Connection Check Requirements

David Stover

Problem: Confounding CC, Detect Results

Figure 145B-3—PSE implementing **CC_DET_SEQ=0**, do_cxn_chk result is dual, staggered power on

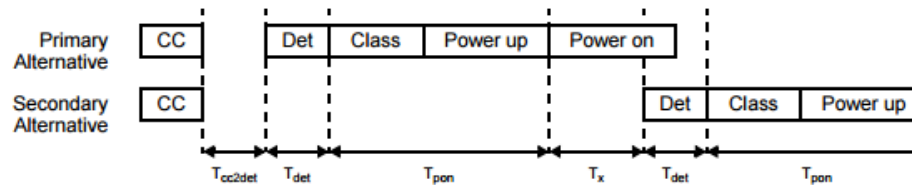
- Connection Check result assumes knowledge of PD detection signature
 - Most CC_DET_SEQ may “discover” dual-signature PD, apply power to a pairset prior to performing detection on both pairsets:

- Today, this “valid/invalid” combination may be interpreted as “sig_type = dual”, leading PSE SD to SISM state
 - In “SISM,” PSE will interpret this PD as dual-signature Class 5 (both utilize class_sig_a = 4, class_sig_b = 3)
- PSE issues 4 class events, allocating 45W to PD
- Single-signature PD interprets 4 class events as a demotion to 60W
- **This is an interoperability issue**

- Option 1: Wholesale fix PSE SD

- Adopt stover_02_0317_option1_baseline.pdf

- Introduces a flexible implementation of existing PSE cxn_chk, detection requirements (timing, electrical)
 - Enables implementations in Annex 145B that do connection check, detections prior to powering either pairset
 - Continues to allow PSEs to power valid pairsets of "valid/invalid" combinations as a 2 pair device (using "pse_alternative", A or B)
 - Allows SISMs to detect, classify simultaneously or staggered
 - Informs SISMs whether to initially re-detect or proceed to classification using existing tpon timers
